Report of Dam Safety Assessment of Coal
Combustion Surface Impoundments
Dayton Power and Light Company
O.H. Hutchings Electric Generating Station
Miamisburg, OH

AMEC Project No. 3-2106-0177.0006

September 2010

Dayton Power and Light Company, O.H. Hutchings Electric Generating Station: East Primary Settling Pond, West Primary Settling Pond, and Secondary Settling Pond were assessed on August 18, 2010.

TITLE
**DAYTON POWER AND LIGHT COMPANY
 O.H. HUTCHINGS STATION, MIAMISBURG, OH
 PLAN VIEW OF SECONDARY SETTLING POND**

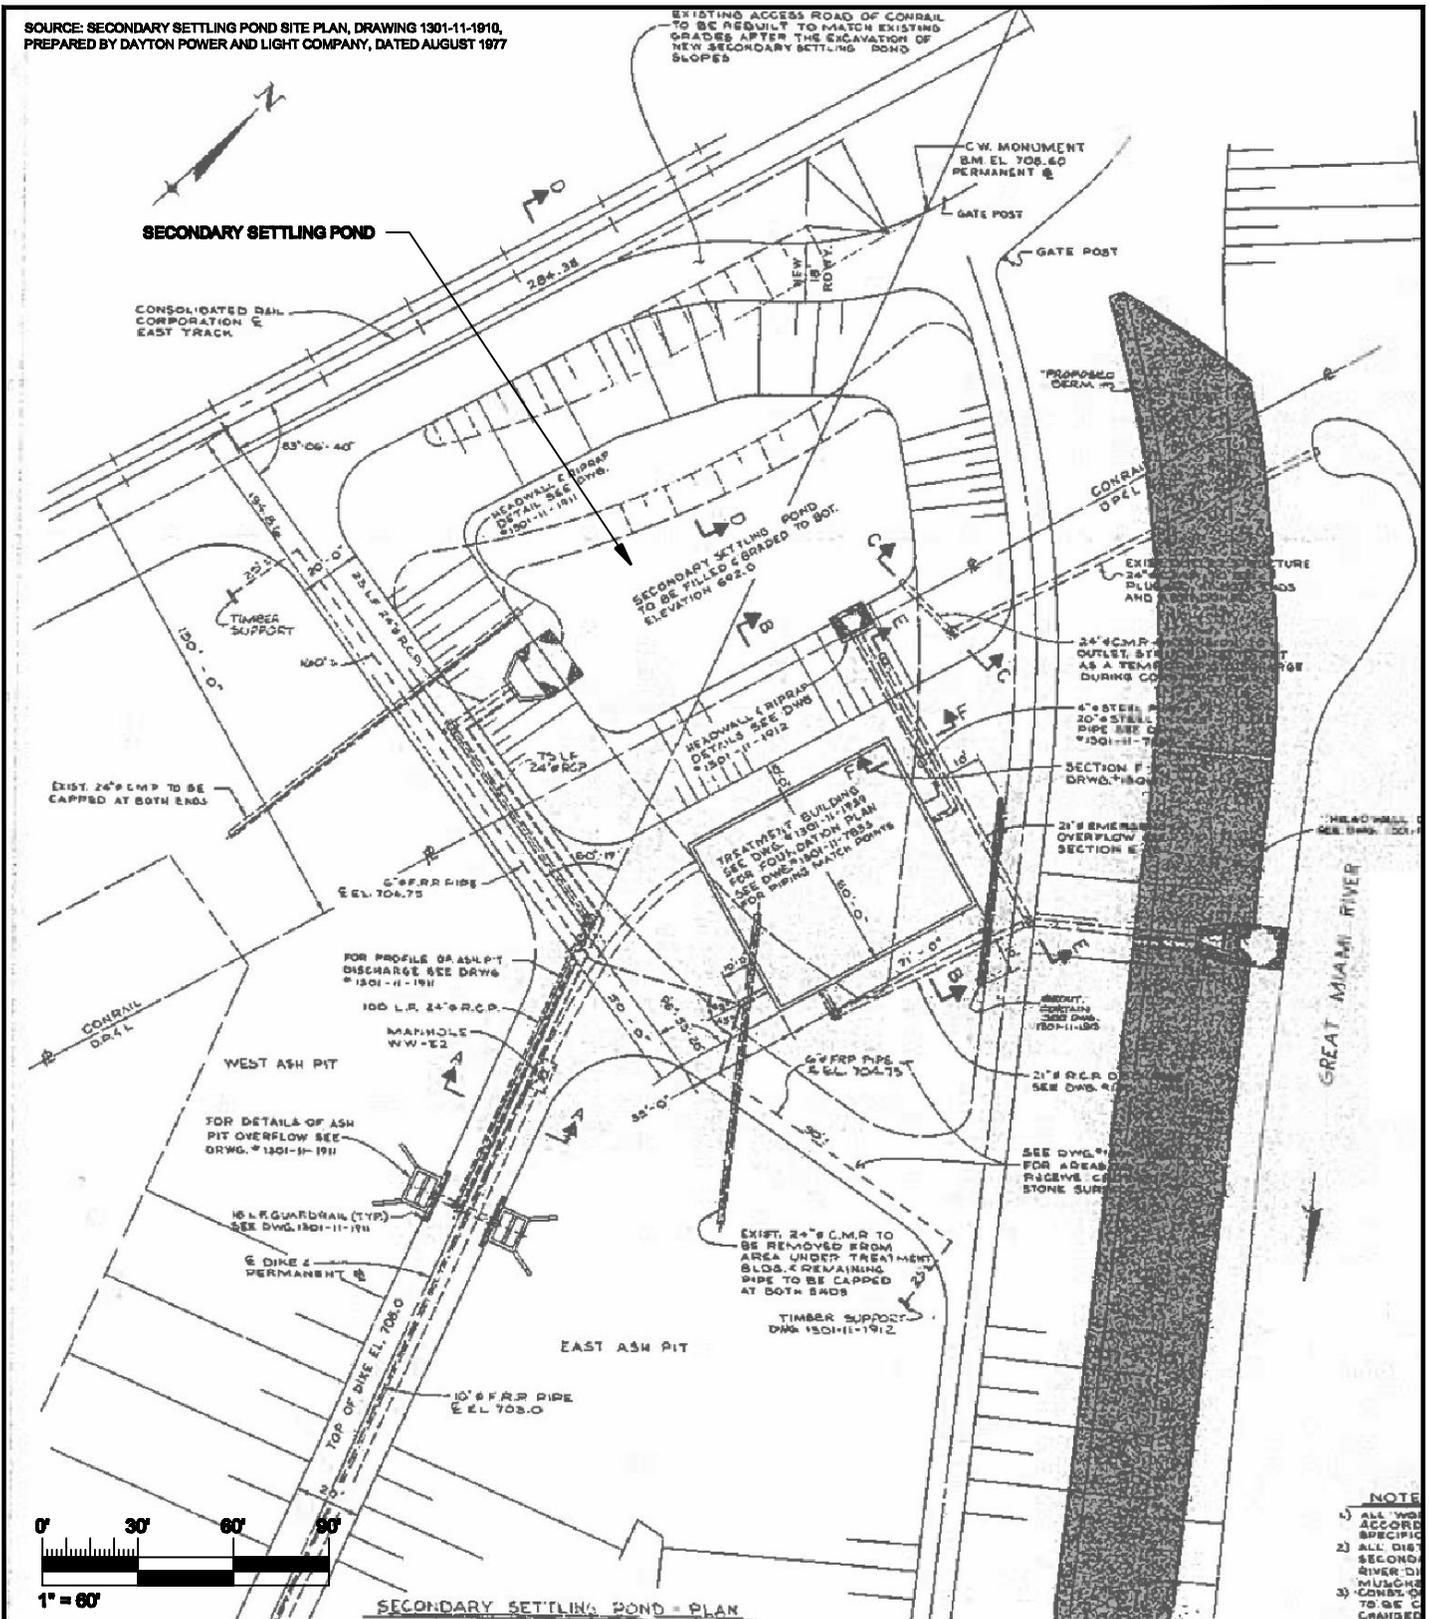
Drawing 1301-11-1910 provided by DP&L illustrates a grout curtain located to the east of the treatment building along the Secondary Settling Pond east crest. Drawing 1301-11-1913 provides a detail of the grout curtain, and states "install grout curtain care taken to avoid damage to 21-inch reinforced concrete pipe (depth may vary)". The drawing indicates the curtain extends from approximate elevation 708 feet to 680.0 feet or lower, at approximately station 0+85. No information was provided regarding the installation of the grout curtain.

Drawing titled "Secondary Settling Pond Site Plan" dated August 1977 indicates a secondary 24-inch RCP outlet. The drawing states that the "outlet structure to act as a temporary discharge during construction." Existence/removal of the pipe cannot be confirmed due to dense vegetation at the time of the site visit.

**SECTION A-A EAST AND WEST PRIMARY SETTLING POND
TYPICAL COMMON DIKE CROSS SECTION**

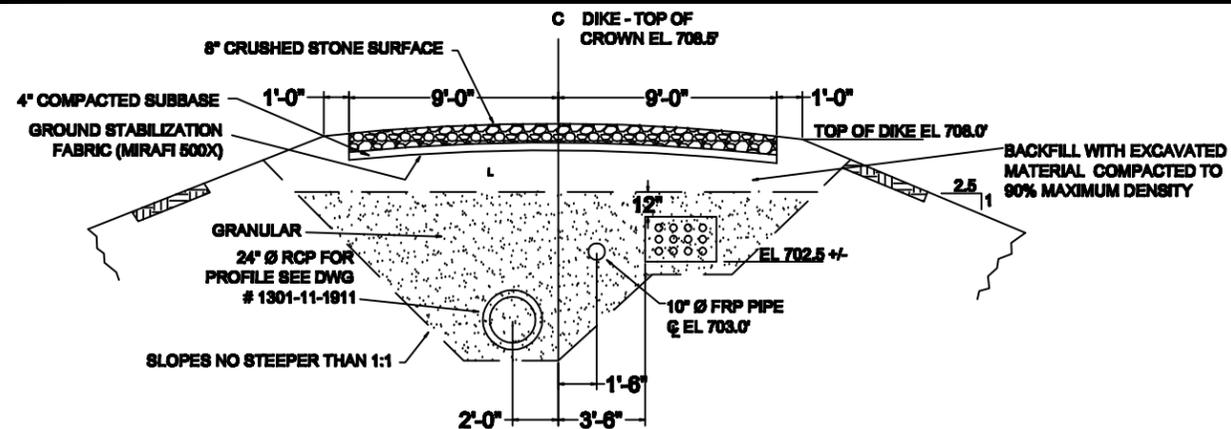
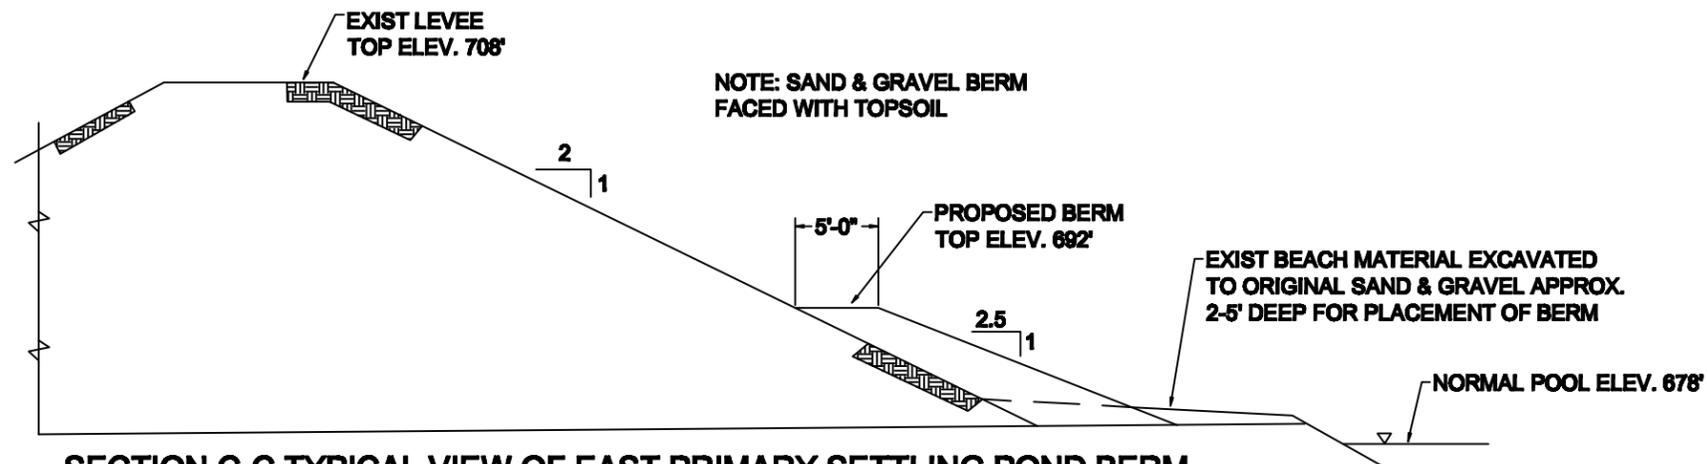
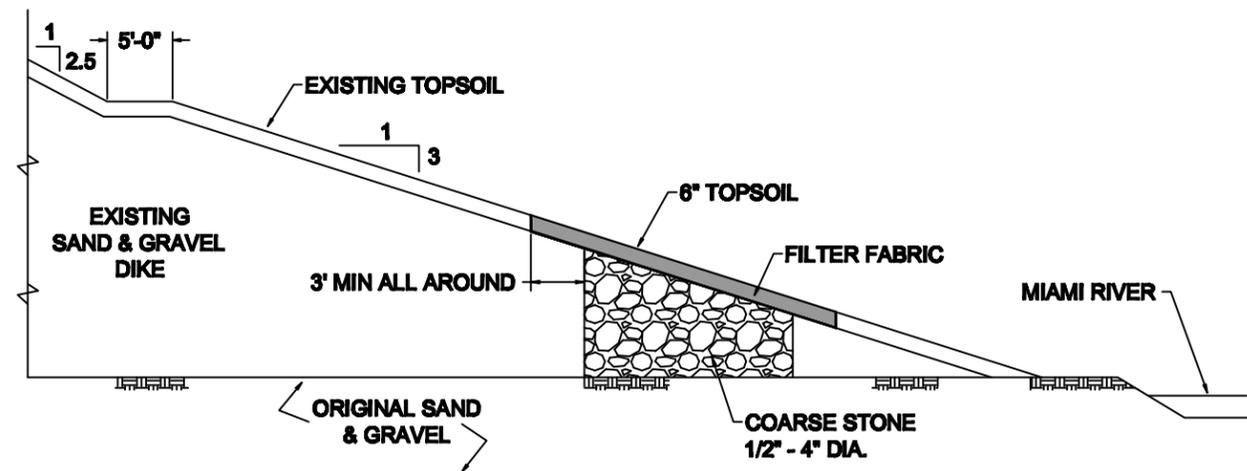
Review of a provided design drawing (1301-11-1902) by AMEC indicate a 2.5H:1V slope along the interior dikes of the common embankment between the East Primary Settling Basin and West Primary Settling Basin. Section C-C of this drawing illustrates an area along the northern section of the east downstream dike of the East Settling Pond with a downstream slope of 2H:1V. A toe berm with a slope of 2.5H:1V constructed 16 feet from the dam crest had been proposed along this cross section. Section D-D labeled "Typical repair method of the dike", is located along the southern portion of the eastern downstream dike of the East Settling Pond and illustrates a repair of the sloughed area. This included a five-foot bench above the repair area, excavating soil from the sloughed area, and filling with coarse stone. Filter fabric was to be placed around the surrounding soil. Downstream slopes of 1H:2.5V are noted along the upper portion of the cross section and slopes for the repair section were reported as 1H:3V. We note that provided drawings did not illustrate a typical cross section around the north or south dike of the East Primary Settling Pond. A plan view and cross sections of the East Primary Settling Pond is included as Figures 4 and 7.

Primary Settling Basin and West Primary Settling Basin. Provided drawings did not illustrate a typical cross section around the north, south, or west dike of the West Primary Settling Pond. A plan view and cross section of the West Primary Settling Pond is included as Figures 4 and 7.

SOURCE: BORING LOCATION PLAN, SHEET 1 OF 2, SOIL INVESTIGATION IN AREA OF ASH PONDS AND TREATMENT FACILITIES, O.H. HUTCHINGS STATION, CHAUTAUQUA, OHIO, PREPARED BY BOWSER MORNER, DATED MAY 17, 1976

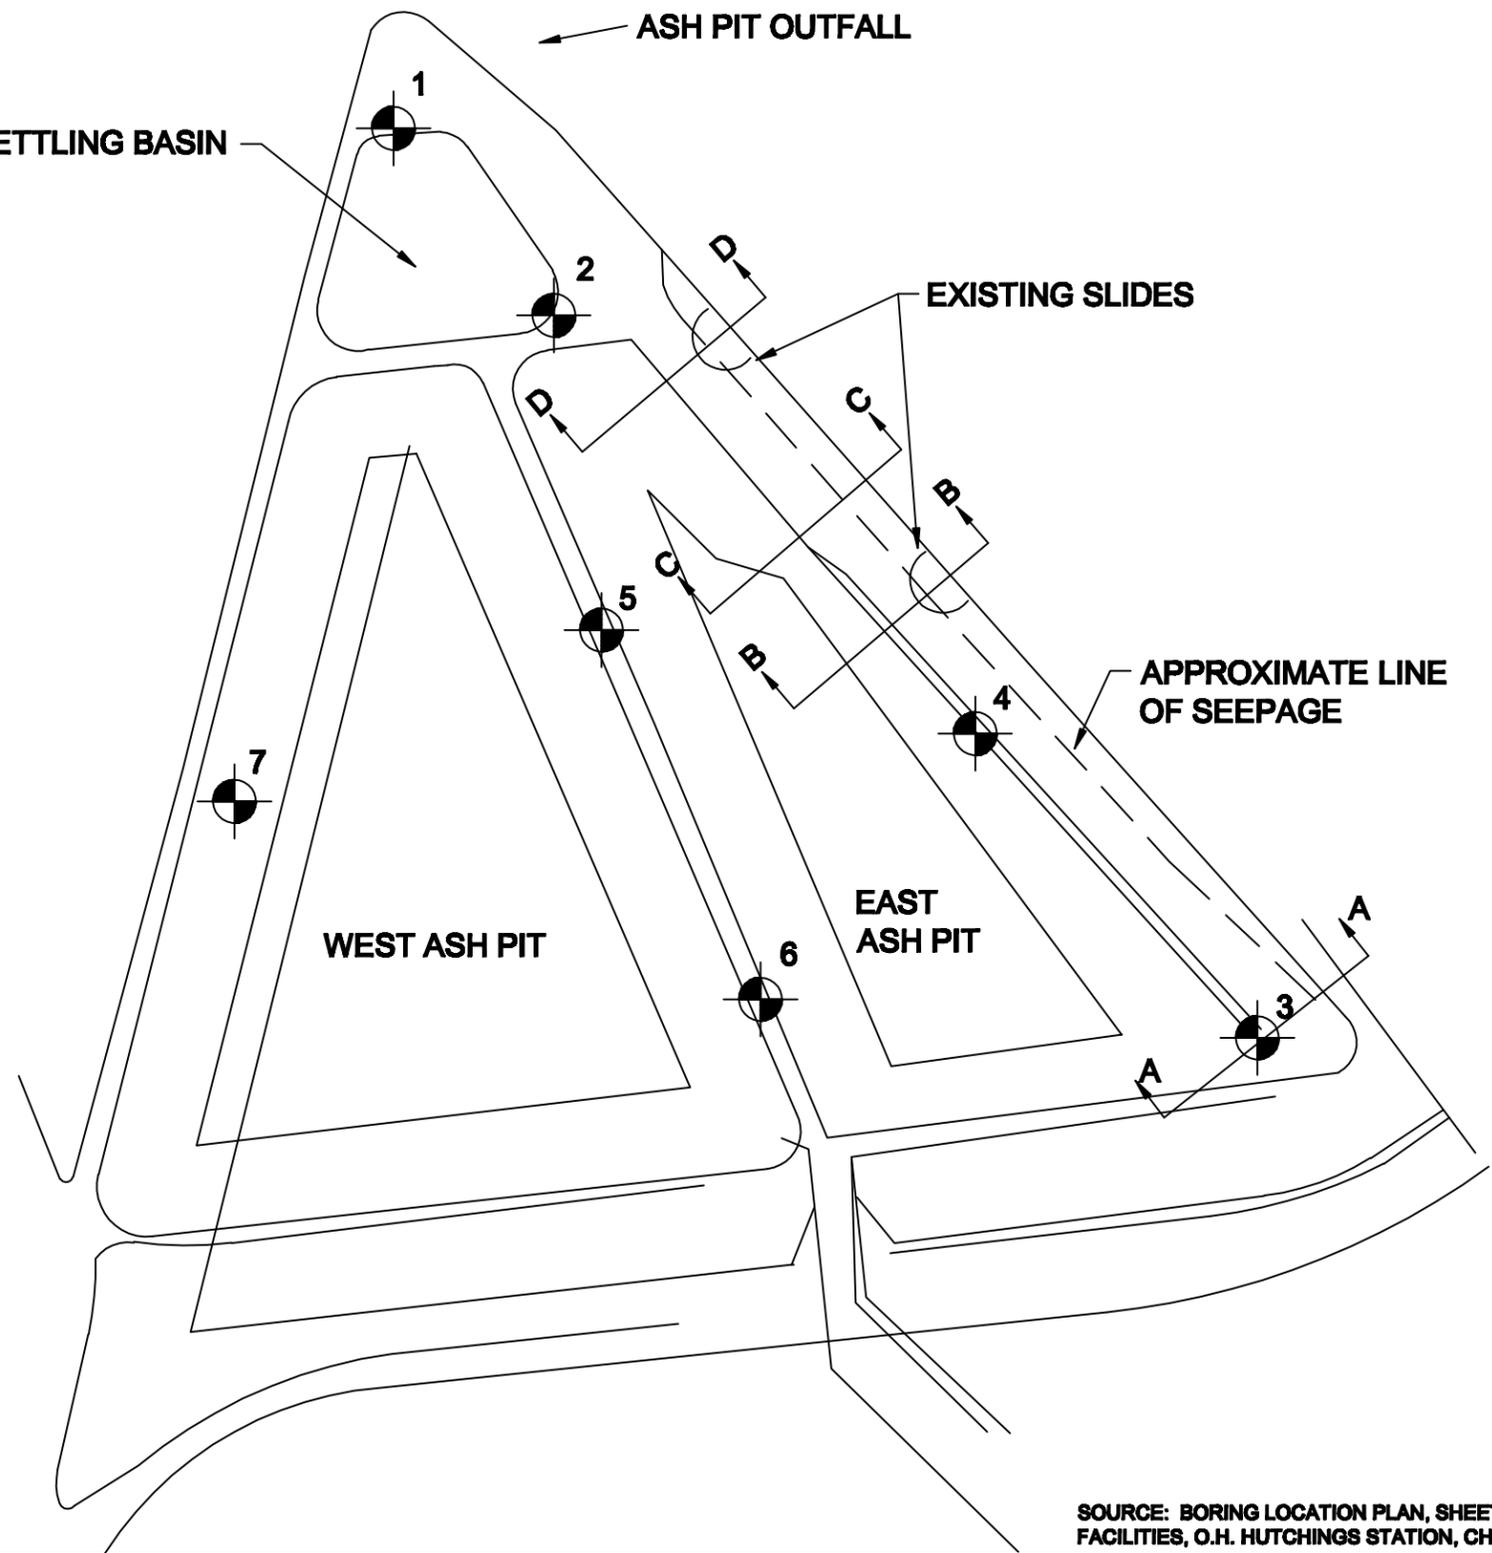
A report entitled *Soil Investigation in Area of Ash Ponds and Treatment Facilities, O.H. Hutchings Station, Chautauqua, Ohio* prepared by Bowser-Morner Testing Laboratories, Inc. dated May 17, 1976 discusses a slope stability analyses performed. The geotechnical exploration program was conducted in February 1976 and included a total of 8 borings varying in depth from 33 feet to 51 feet below ground surface. Boring locations are illustrated on Figure 8. Nine in-place permeability tests were conducted during the drilling exploration. Based on the average results, the average coefficient of permeability in the fill and original sand and gravel is equal to 7×10^{-3} centimeters per second and 1.4×10^{-2} centimeters per second, respectively. The report states that an on-site inspection was performed to determine the seepage conditions and location and extent of the existing slides. Cross sections of the dike were taken at four different locations. Figure 8 illustrates the location of the slides, and extent of the seepage.

Slope stability analyses were “performed on the cross section of the existing dike provided by the client.” The analyses were conducted by a computer program utilizing a Modified Bishop method of slices. The factors of safety for the different failure circles were determined. All failures were assumed in the long term condition and are based on the results of the triaxial tests. Assumed strength parameters were used for the underlying original black organic silty and the original toe materials. The location of the phreatic surface was determined from the depths of water encountered during drilling operations, and on the seepage conditions determined from the on-site inspection. Earthquake forces were included, with a coefficient of earthquake design of 0.05, which is indicative Zone 1 earthquake zone for the United States.
